Federal Recall Information

08KW7

Kenworth Truck Company

T300/T270/T370 Fuel Line Interference

Fig. 2

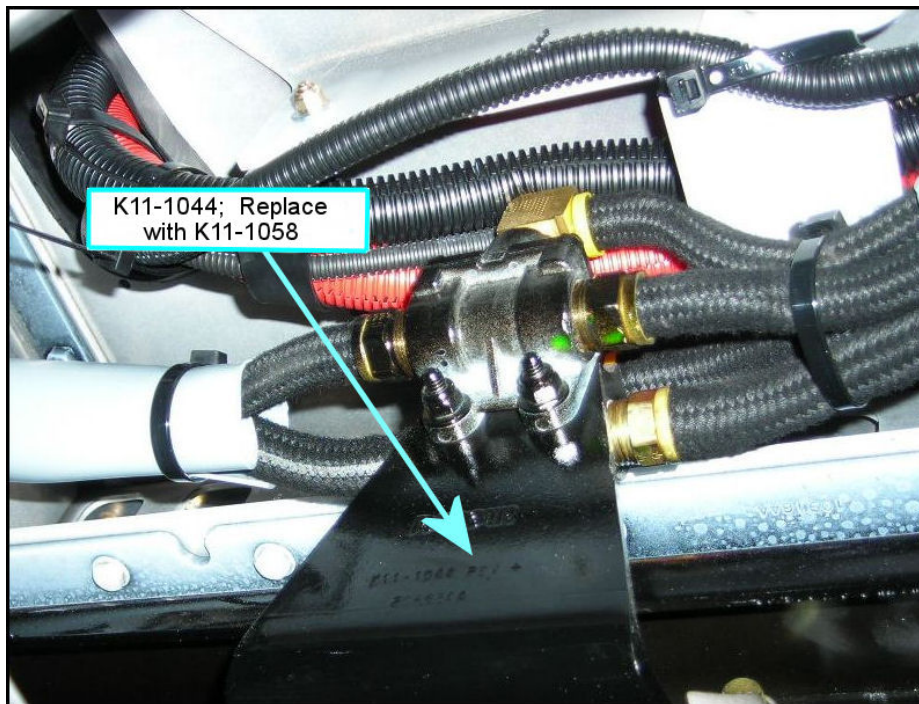
Under the cab, locate and replace the existing K11-1044 fuel splitter valve bracket with a new K11-1058 bracket, using the same mounting holes and hardware (see Fig. 2).

Fig. 3

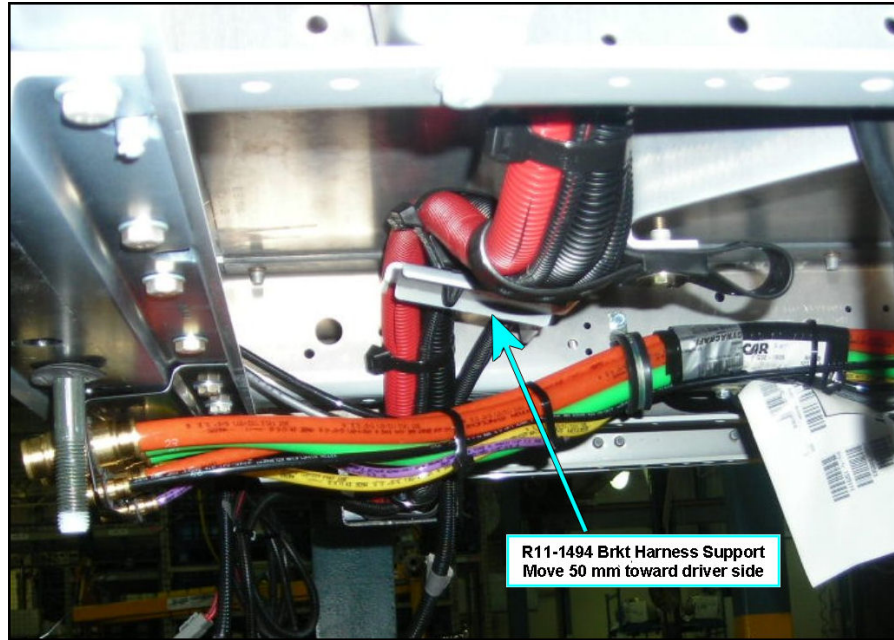
Relocate the R11-1494 harness support bracket 50 mm toward the driver's side along the R11-1492 cable routing bracket. First remove the R11-1494, drill two new 7 mm holes 50 mm toward the driver's side in the R11-1492 bracket, and reinstall the R11-1494 bracket (see Fig. 3).
